ENGINEERING CHANGE ORDER

PRODUCT EFFECTED XPANDER	DRAWINGS EFFECTED VOICE SCHEMATIC 1814 SHEET 3, 4 VOICE PARTS LAYOUT 1813B	ECO NO. 602 PAGE 2 OF 2
-----------------------------	--	-------------------------------

ECO No
603

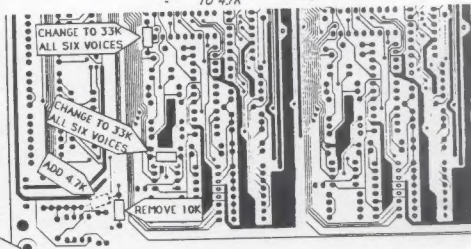
REMOVE DISTORTION IN VOICE'S FINAL VCA,
AND DECREASE VCA BYPASSING.

6. REMOVE 12 10K RESISTORS (RX62 AND RX70)
AND REPLACE WITH 33K RESISTORS (478333).
7. REMOVE 10K RESISTOR (R186) AND REPLACE
WITH 4.7K RESISTOR (478472) IN NEW
POSITION AS SHOWN.
